OFFICIAL NOTICE AND AGENDA

Meeting of the:	**PLAN COMMISSION OF THE CITY OF WAUSAU**
Date/Time:	**Wednesday, June 16, 2021 at 5:00 pm.**
Location:	**City Hall (407 Grant Street, Wausau WI 54403) - COMMON COUNCIL CHAMBERS**
Members:	Katie Rosenberg (C), Eric Lindman, Pat Peckham, Tom Neal, Bruce Bohlken, Andrew Brueggeman, George Bornemann

From: Brad Lenz
To: Plan Commission
Date: June 10, 2021
Subject: Amend PUD at 1200 N. River Drive to allow for three mixed-use buildings

From: Sam Wessel
To: Plan Commission
Date: June 16, 2021
Subject: Planned Unit Development at 1520 and 1601 Elm Street

Image 1. Previous General Development Plan

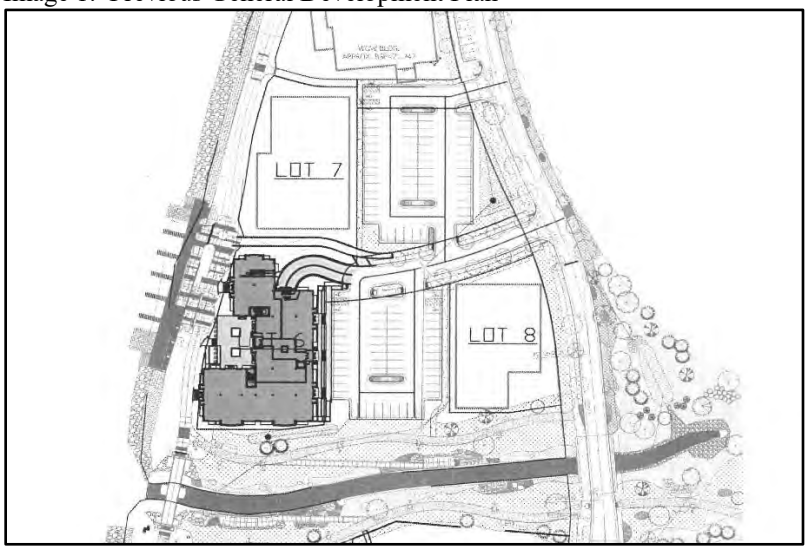
The shaded building in the image above was the original concept for a "mixed use" building, which was actually a commercial building with different tenants. Lots 7 and 8 on the plan were being shown as building pads for future development, the particulars of which had not been decided at the time of the plan. The current action of amending the general development plan would specify the uses on lots 7 and 8 as well as change the former commercial building to a mixed-use building that is mostly residential.

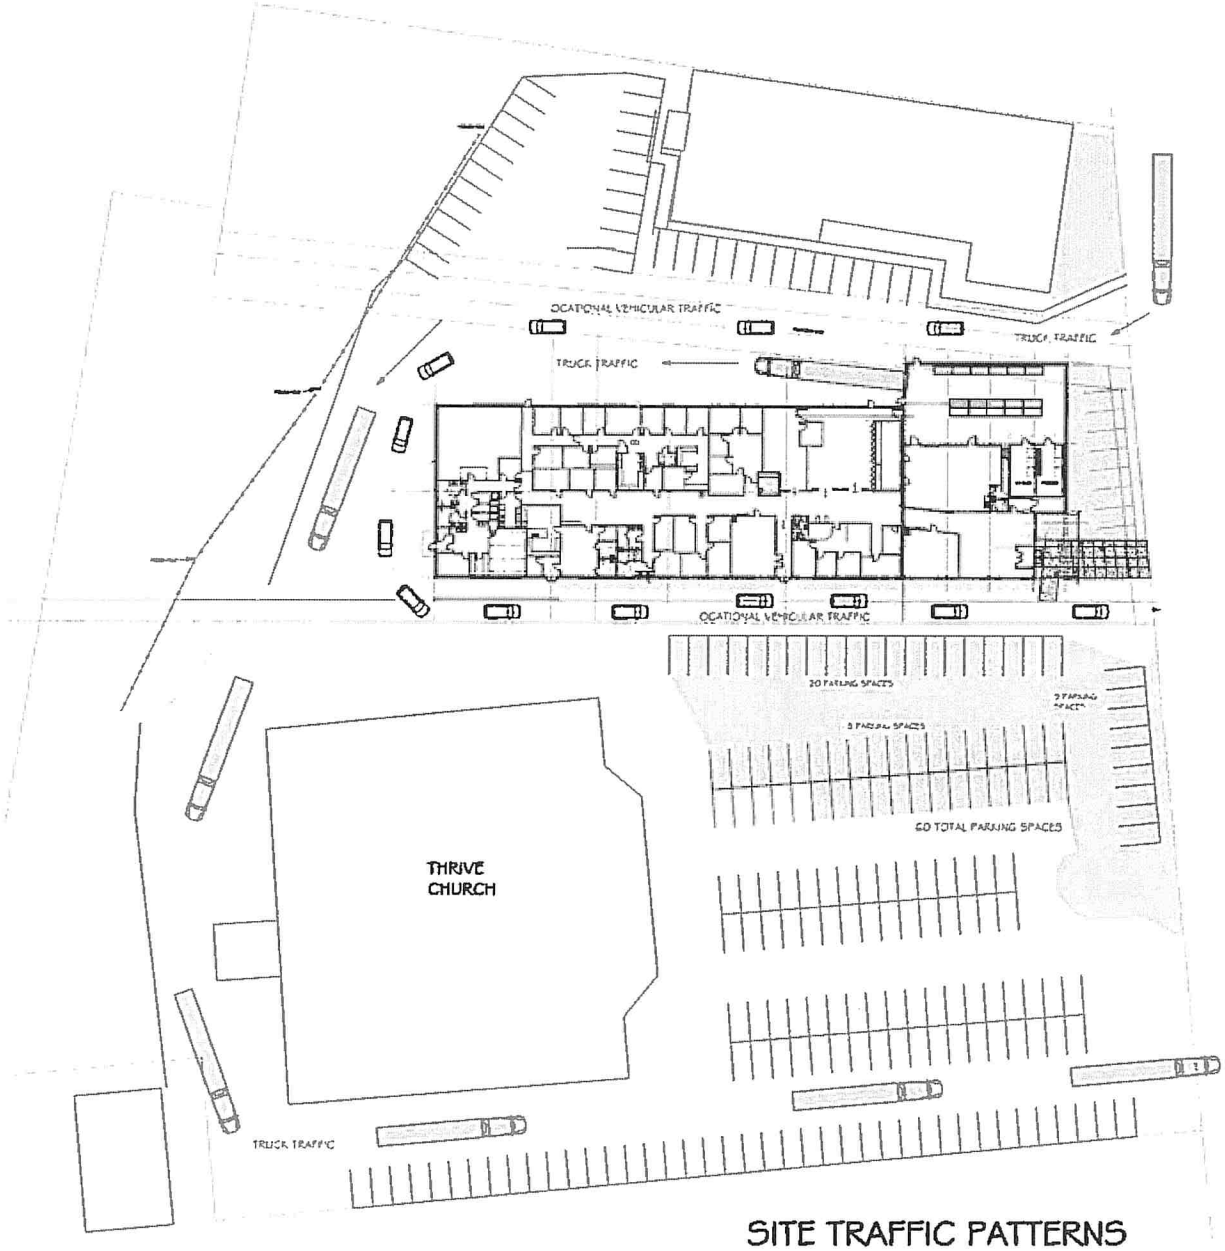
The proposed use includes a 7,000 square foot addition on the east side of the existing building which fronts Grand Avenue and enhances the building's façade with large windows. This addition essentially eliminates existing parking on the site. Though Section 23.03.12 (10) of the City's zoning ordinance does not provide parking minimums specific to homeless shelters, Section 23.06.06 of the City's zoning ordinance requires 1 parking space per 400 square feet in excess of 2,000 square feet of office space. For a 25,000 square foot building, this equals 57 spaces (53 if the 4,000 foot homeless shelter is excluded from the calculation). Therefore, the removal of the site's only parking area must be addressed.

The attached site plan depicts 60 existing parking spaces available for the site located on the Thrive Church property immediately to the south. Staff recommends requiring a long-term parking agreement to be maintained between the two properties as a condition for approval to ensure these spaces remain available for the site should there be an eventual change in property ownership.

Since the attached site plan addresses potentials concerns over the parking availability, staff recommends approving the conditional use contingent on maintaining a long-term parking agreement to ensure the availability of the depicted 60 spaces on the Thrive Church property.

33 ARCHITECTURAL SITE PLAN
1" = 20'-0" 4 / A200

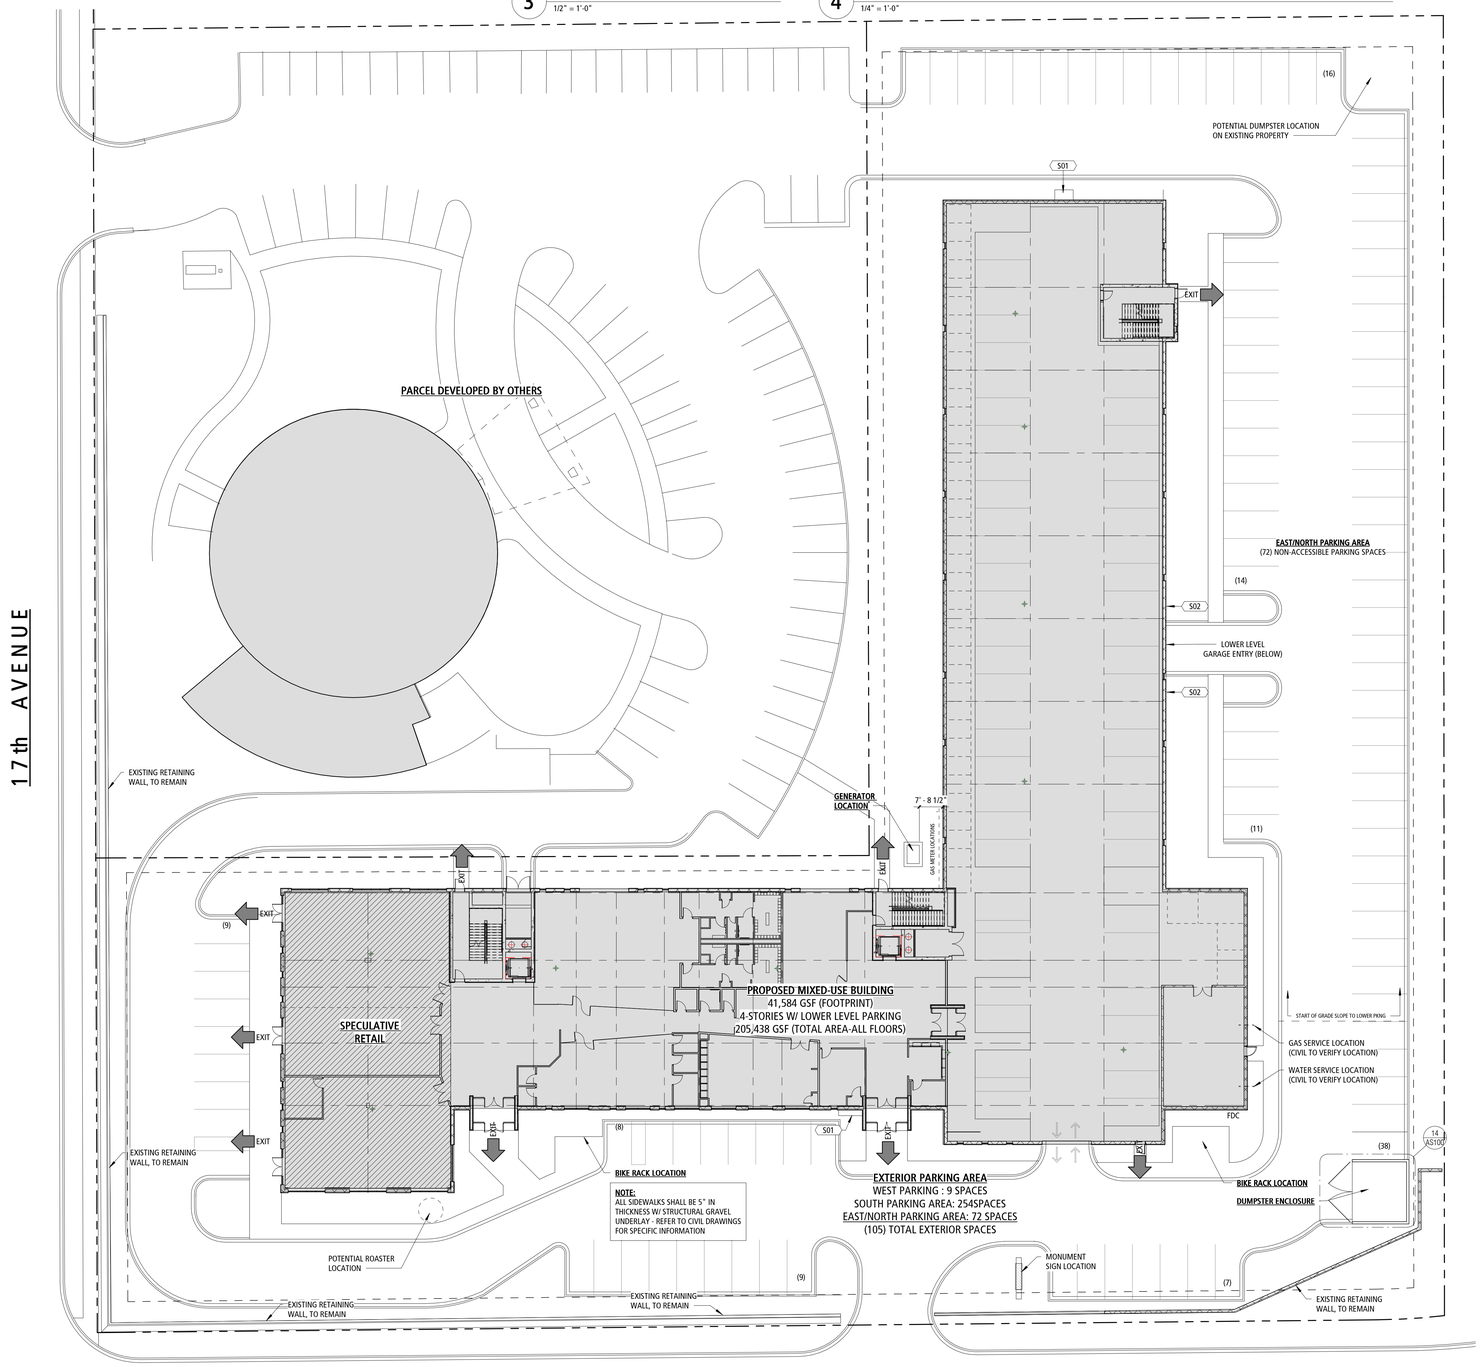
The residential component of this development requires 162 parking spaces based on the number and type of units and configuration as a mixed use development under Section 23.06.06 of the City's Zoning Ordinance. Though retail and restaurant space occupies only a small share of the building's total square footage, all parking areas combined provide an additional 165 spaces for a total of 327 spaces on the two properties. Additionally, the City's Landscaping Ordinance requires landscaping islands to be placed at least every 180 linear feet of parking stalls under Section 23.08.30 (2)(d), which the attached plans do not depict. Since parking exceeds both minimum and maximum parking requirements and lacks required landscaping, staff recommends requiring the provision of landscaped islands as a condition of this SIP's approval. This also
